ADDENDUM NO.1

Ayer West Main Street Infrastructure Project, No. 21DPW11  
Ayer DPW

This addendum amends and/or supplements the bid documents as indicated below. Only these items alter the Bid Documents; any verbal discussions or responses are hereby declared null and void.

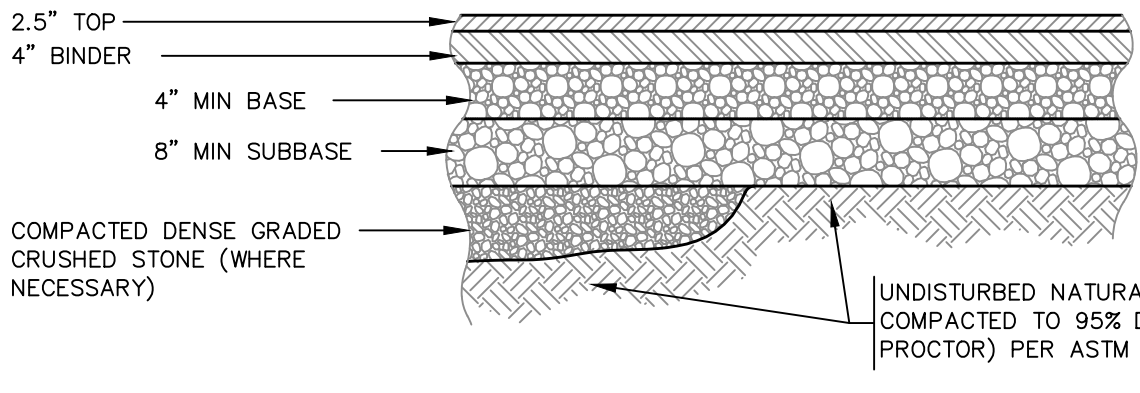
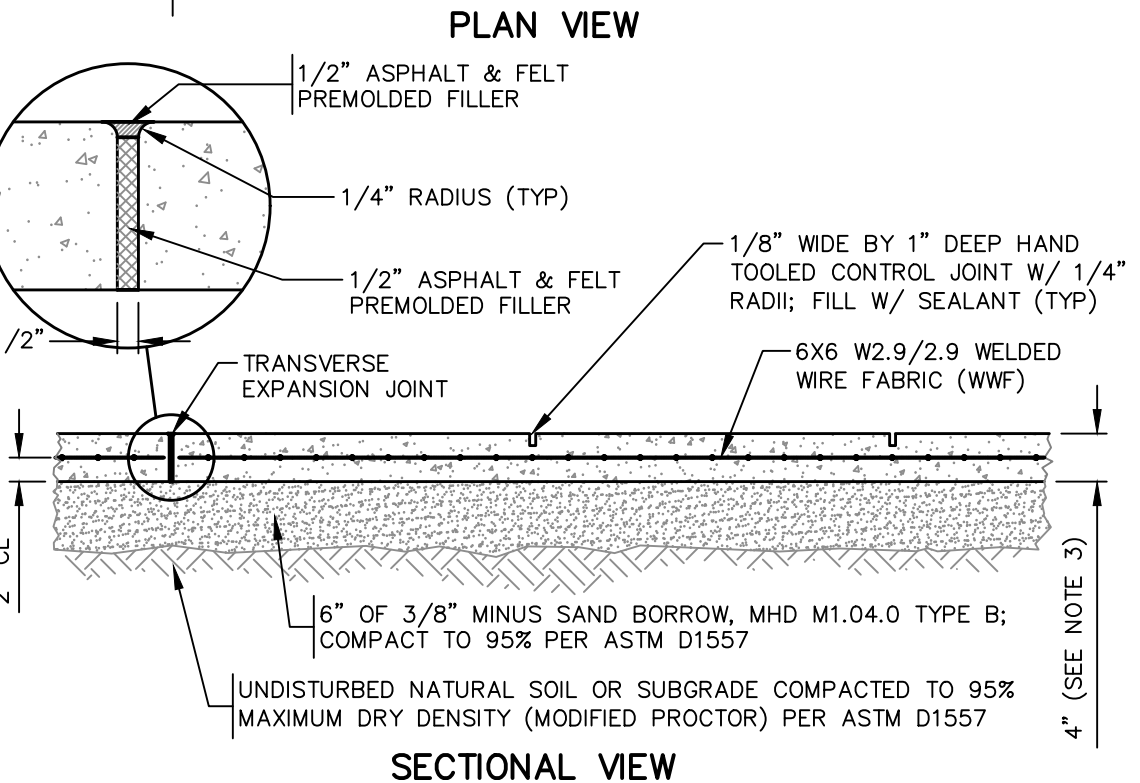
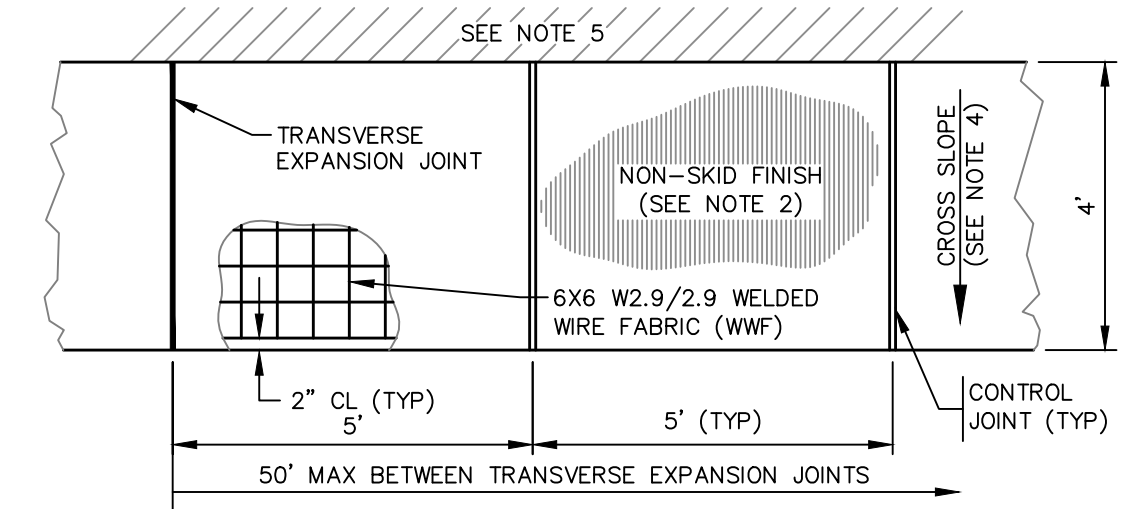
- A. The following changes include but are not limited to:
    - Revised Detail 7 on Sheet C3.
    - C4 – Added detail for SiltPrison accessory to catch basin.

3. **On sheet C-3 detail 3/7 states untreated base and subbase, yet in the section 02503 indicates reclaim to be treated. Which is correct?**

- 23. The sections A-A, B-B, C-C on sheet C3 all refer to "See bituminous pavement detail". When looking at the detail 7/C3, the pavement detail shows 4" min. untreated base and 8" min. untreated subbase. Reclaimed pavement borrow is not mentioned or shown on these cross sections. Please provide definitions for untreated base and untreated subbase. Is this reclaimed pavement borrow or dense graded or gravel borrow?**

Response: The reclaim is to be treated. Detail 7 has been revised to remove the word "Untreated".

Response: Paving notes have been added to the detail to indicate areas of reclaim.

**TYPICAL CATCH BASIN WITH SILTPRISON DETAIL**

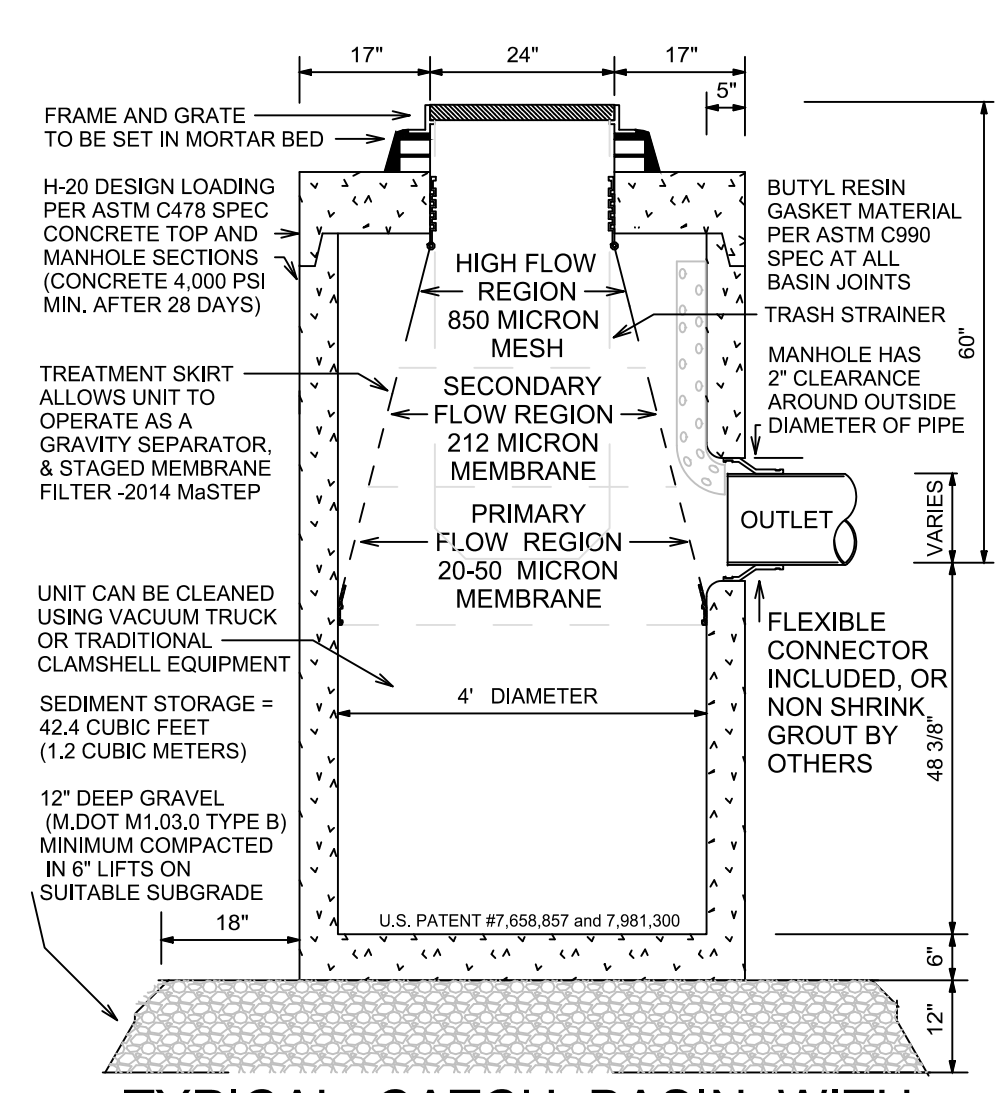
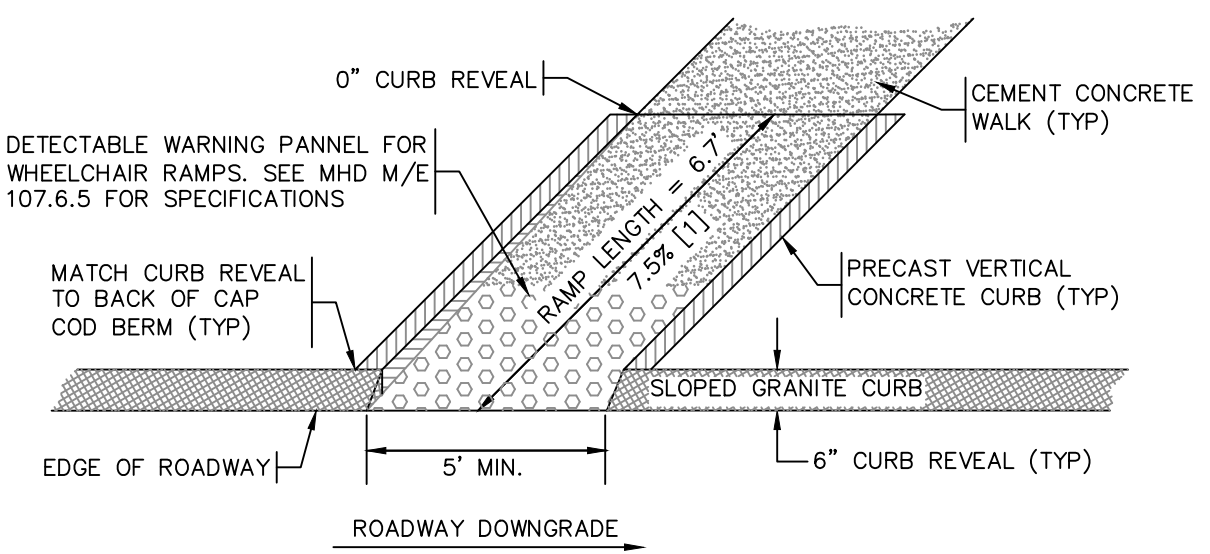
1. **Which SiltPrison are you looking for? 160D, 160DP, 160R. can a detail be supplied in which to use ?**

Response: We are specifying SiltPrison 160D. Please see detail added to Sheet C4.

C9

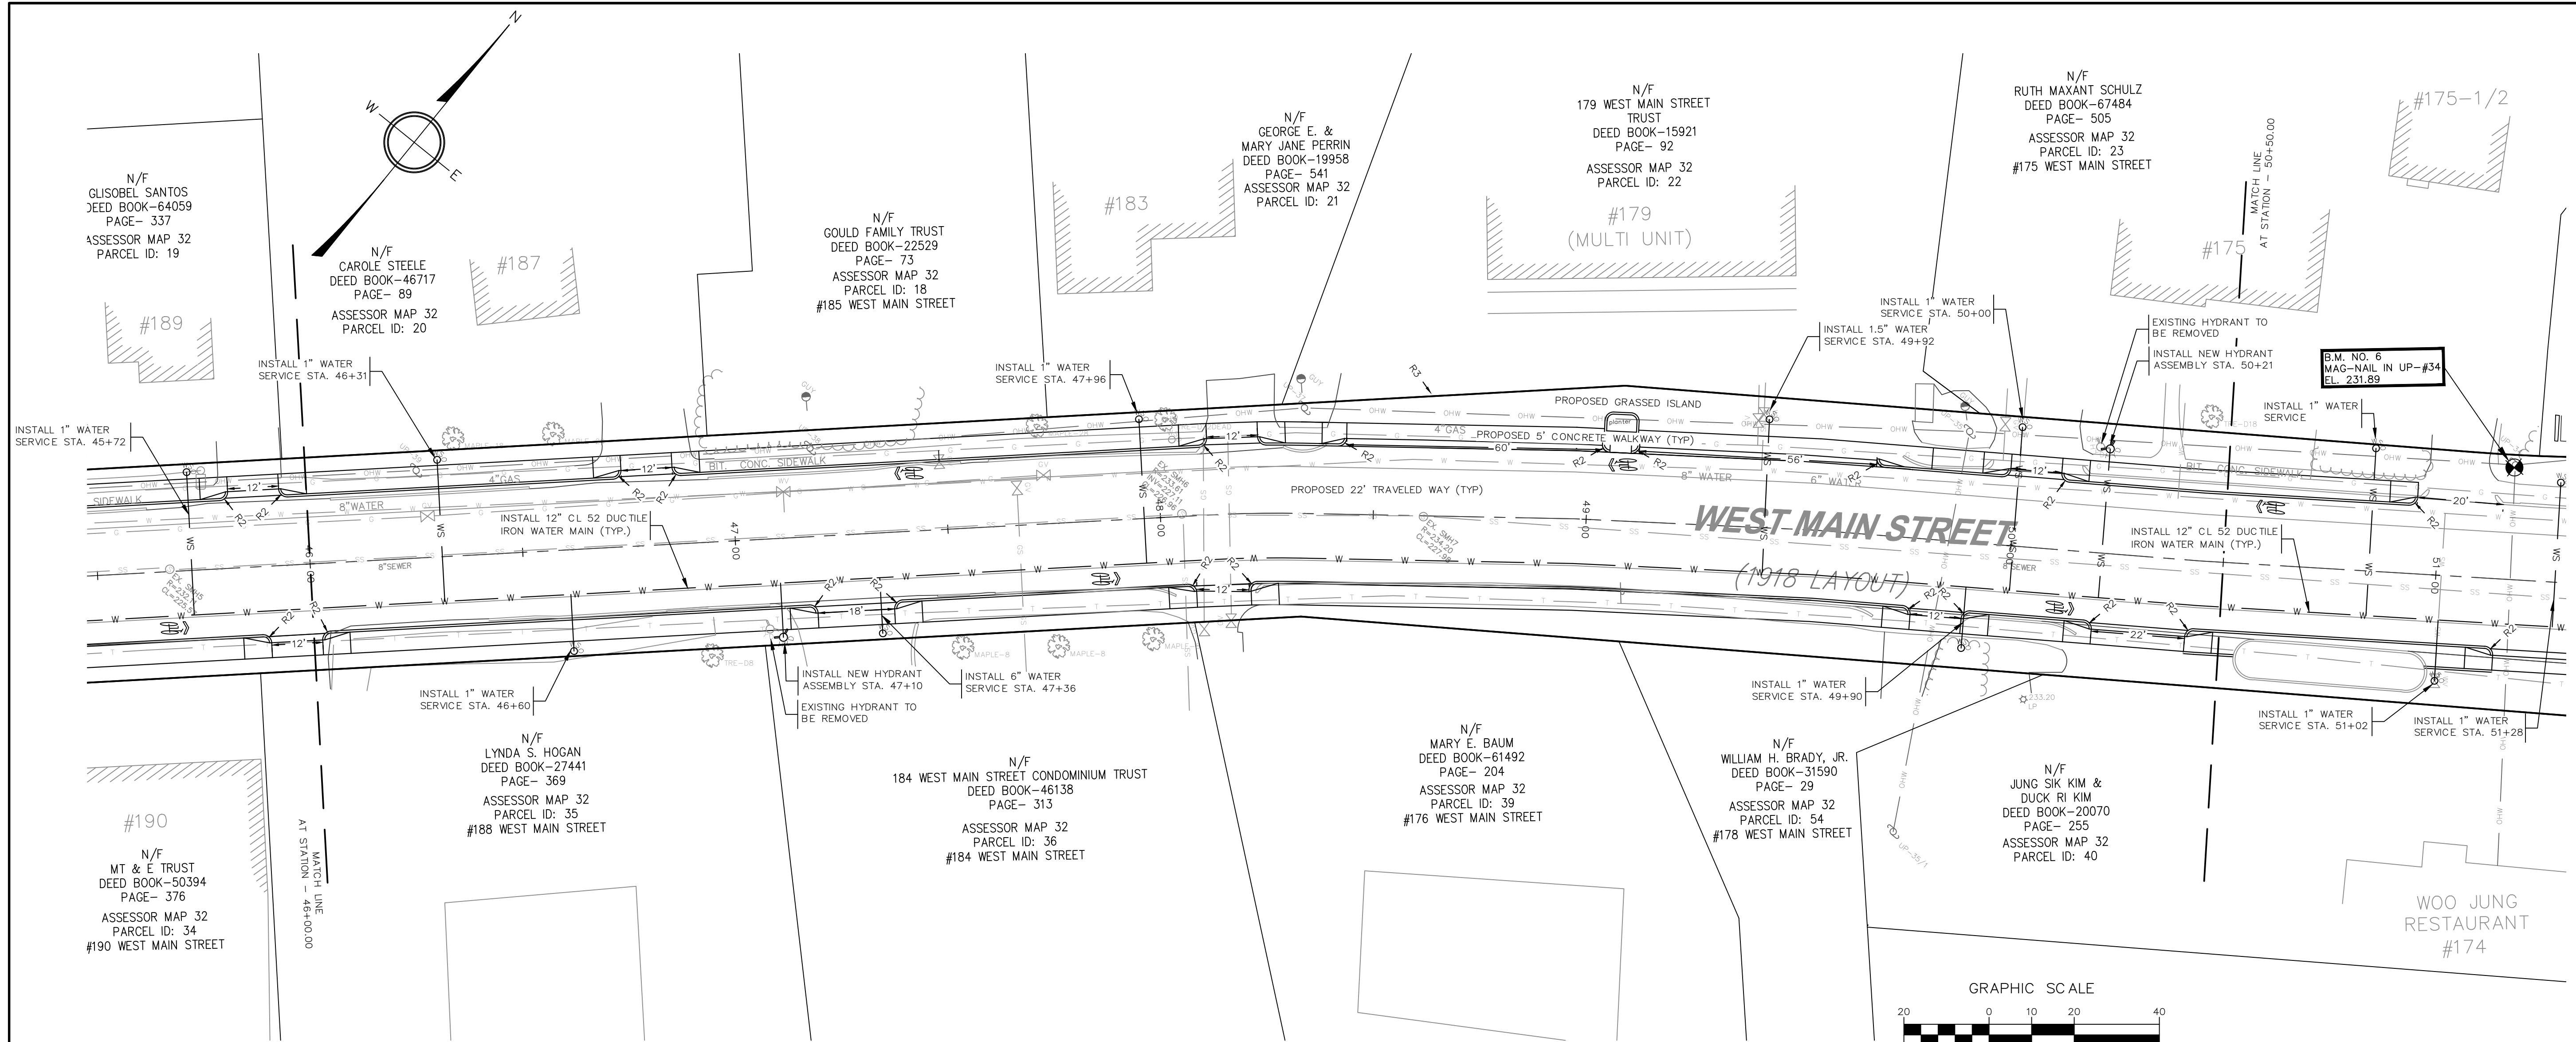
- Deleted callout on Sheet C9 “CONTRACTOR TO FIELD LOCATED AND FILL EXISTING IC VAULT WITH SAND AND ABANDON IN PLACE 12”A/C TO BE GROUTED IN FULL” and replaced with “CONTRACTOR TO FIELD LOCATE AND FILL EXISTING IC VAULT WITH SAND, CONTRACTOR SHALL CUT AND CAP EXISTING 12”AC WATER MAIN CONNECTING TO IC VAULT AT THE JOB CORP PROPERTY LINE”. Also showing the existing 12” AC water main toward Job Corps.

**9. On sheet C-9 shows the Interconnection Vault And Appurtenances, it shows 12x8 tee's and 8" DI going into the vault, on sheet C-4.1 in the detail shows the 12" DI coming into the vault and reducing down to 8" in the vault. Which is correct ?**

Response: Sheet C9 is correct, showing the 8-inch reduction via the tee connection to the 12-inch water main.
